Louisville Revitalization Commission

SUBJECT: DOWNTOWN FRONT AND CENTER UPDATE

City Staff will provide an update to the LRC on the revisions and additions made to the Downtown Front & Center concept plan based on LRC feedback provided at the March 25th meeting. The project team has developed a full range of improvement options that can be selected and prioritized to fit within the available project budget in the attached revised concept plans. Presented below is a summary of major comments provided by LRC at the previous meeting and via email and an explanation of how those comments have been incorporated into the revised concept plans:

CITY OF LOUISVILLE FRONT & CENTER PROJECT REVISED CONCEPT PLANS

PLAN ALTERNATIVE WITH RELOCATED WATER FEATURE

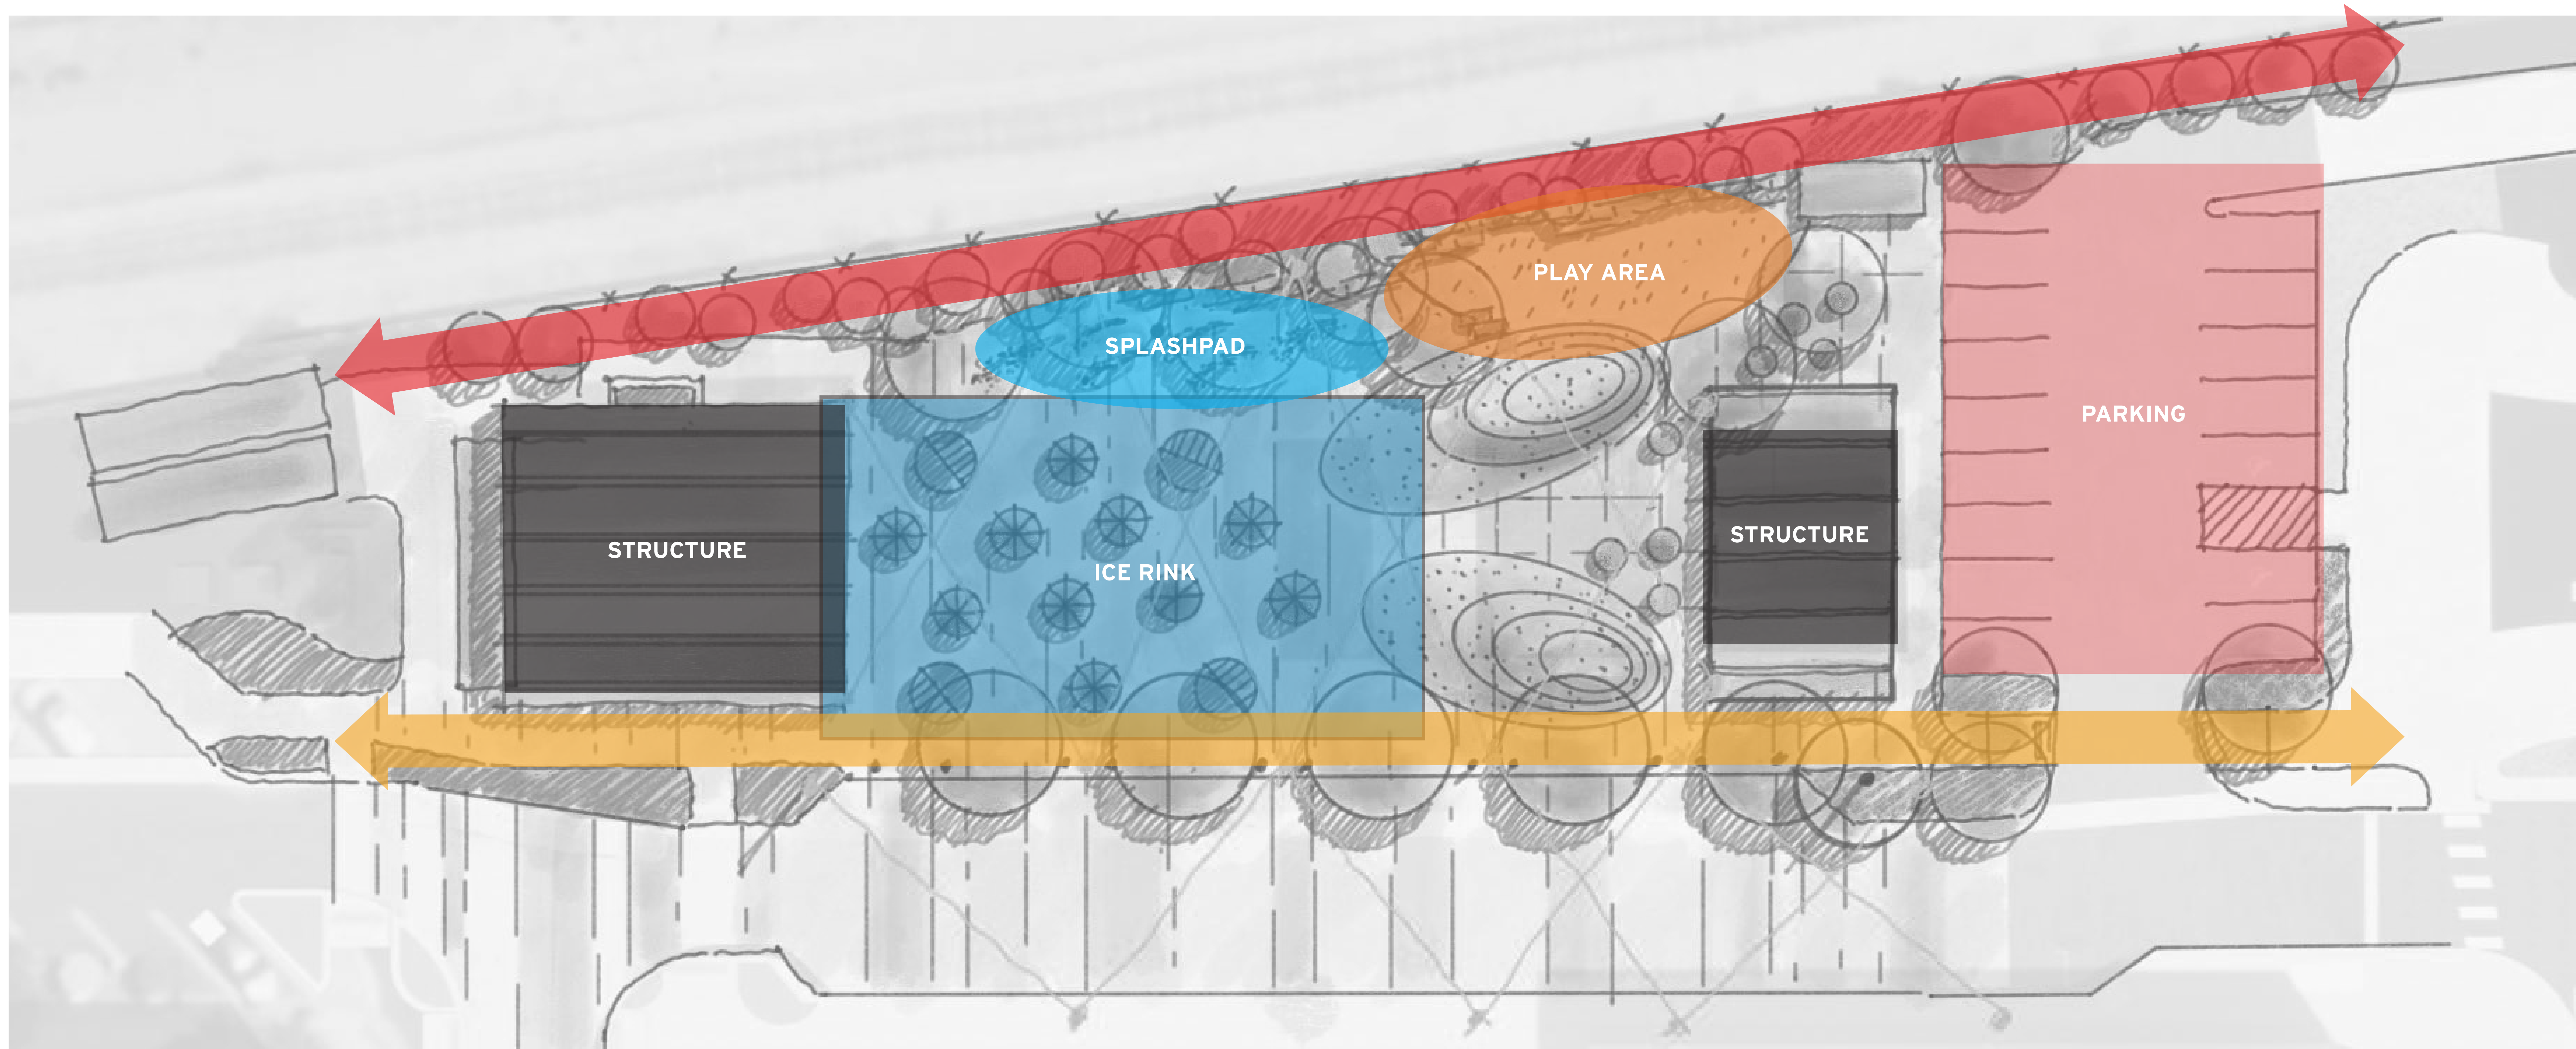
- Explore other location and style options for splashpad and turf mounds.
 - *Splash pad has been relocated to the east side adjacent to the playground and is more integrated with the other elements of the plaza.*

- Given that Street Faire and chamber have expressed concerns about the mound location, perhaps it could be reoriented/integrated into the playground area, opening up the center of the pavilion patio space for better flow. I imagine children will use it to run and/or roll down, in which case use of sod for that area alone could make sense. It could still serve as an elevated seating area but would be tucked to the side.

- I would also like to see alternative design options for the turf. I'm still opposed to artificial turf on such a large expanse of ground and don't think it will be used in the same way natural turf would. I don't think it's a good look for a city park. Aside from all the environmental implications, as designed adjacent to the splash pad, once it gets wet, it could become quite slippery, increasing the risk of falls and injury.

- *The mound configuration has been reconfigured into two mounds at the edges of the plaza. This opens up the center of the patio space and allows for a mound adjacent to the playground area while still allowing the mounds to function as seating.*

- *Two options were considered for the green space area that's recommended to break up the hardscape: artificial turf and sod. The City's Parks Department recommends artificial turf for ease of maintenance and water conservation. The project team and city staff have toured several turf installations and have found that they would function adequately at Steinbaugh plaza. A product data sheet for the proposed artificial turf product is included as an attachment to this memo. Sod would likely struggle with the foot traffic generated by events at the plaza and would potentially need replacement on an annual basis.*

STEINBAUGH PAVILION STAGE HEIGHT STUDY

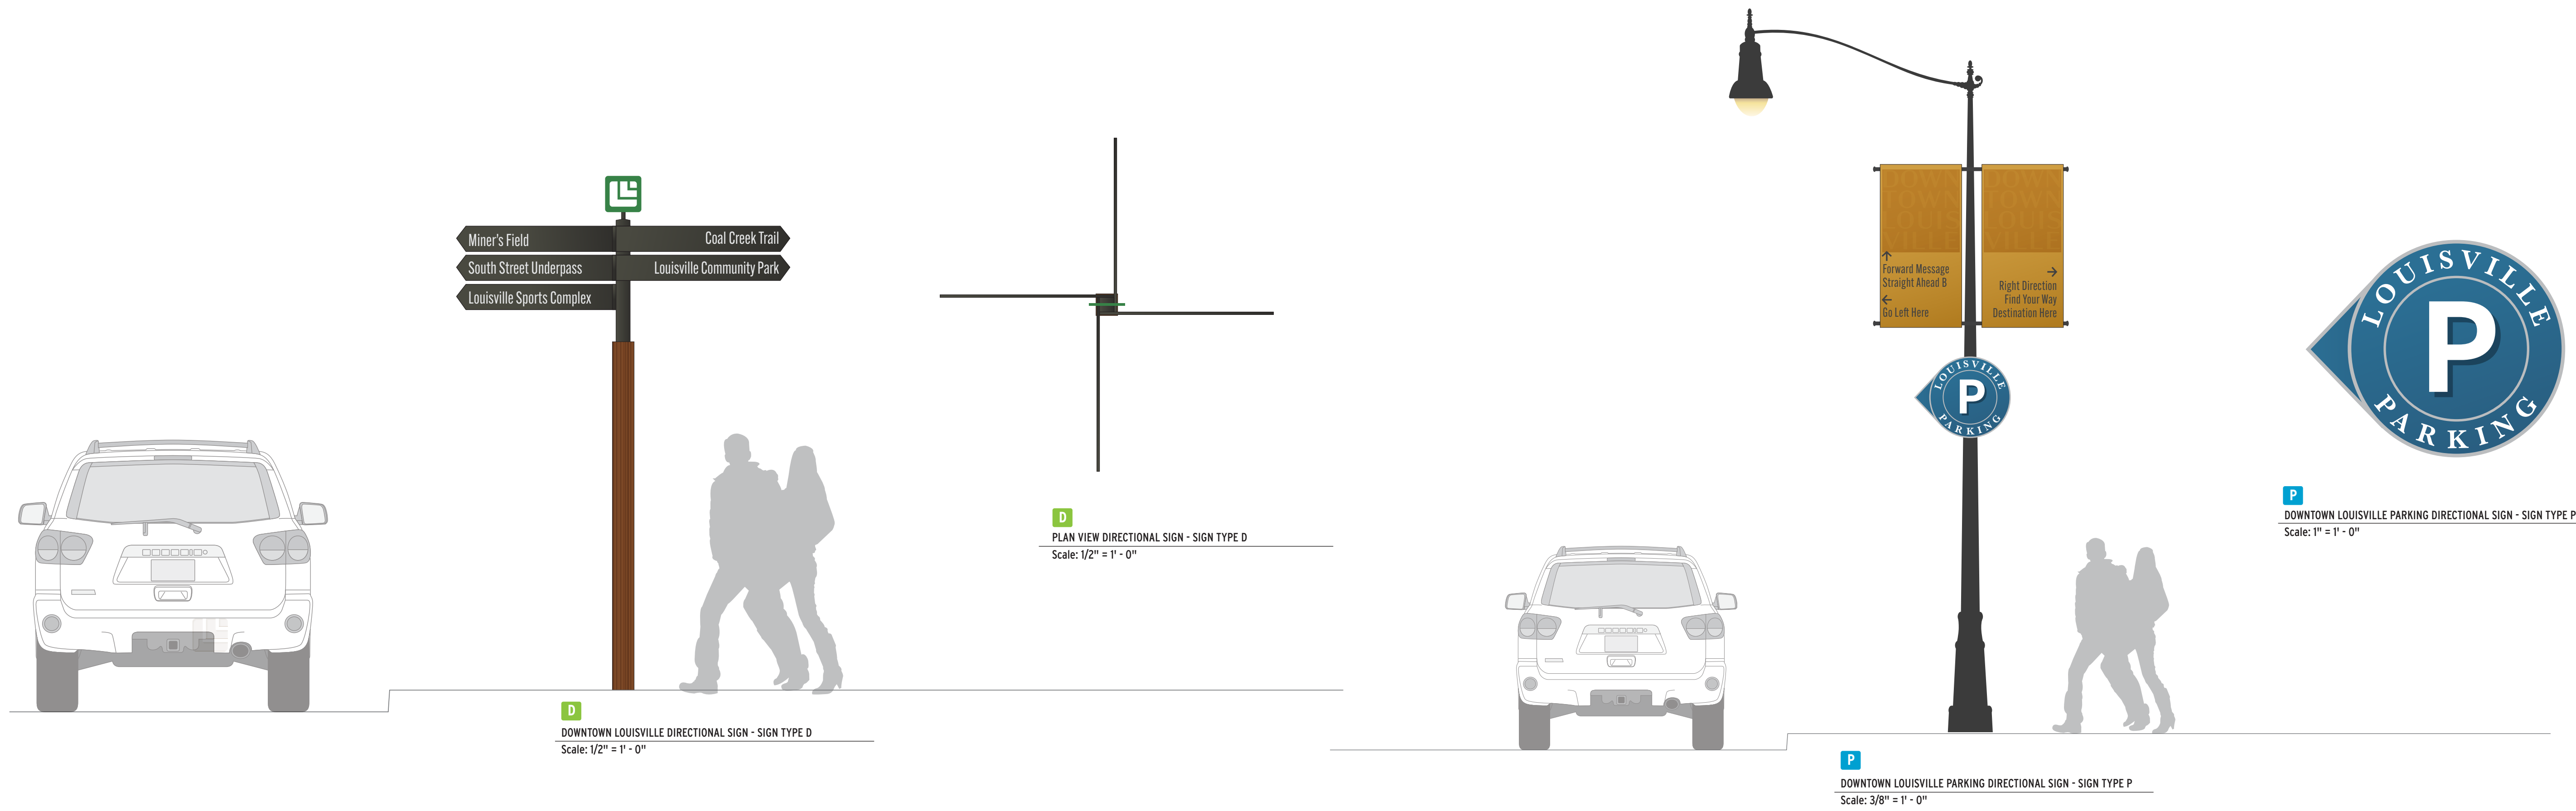
- Locate a good area for a bike corral.
 - *A location north of the pavilion is proposed in the attached conceptual design package.*
- Explore different stage heights for the main pavilion.

- *Renderings are shown in the conceptual design package for a 3', 4', and 5' stage height. The project team recommends a 3' height for day-to-day use, safety, and maximum flexibility. A small platform stage could be brought in for larger events to elevate the stage.*
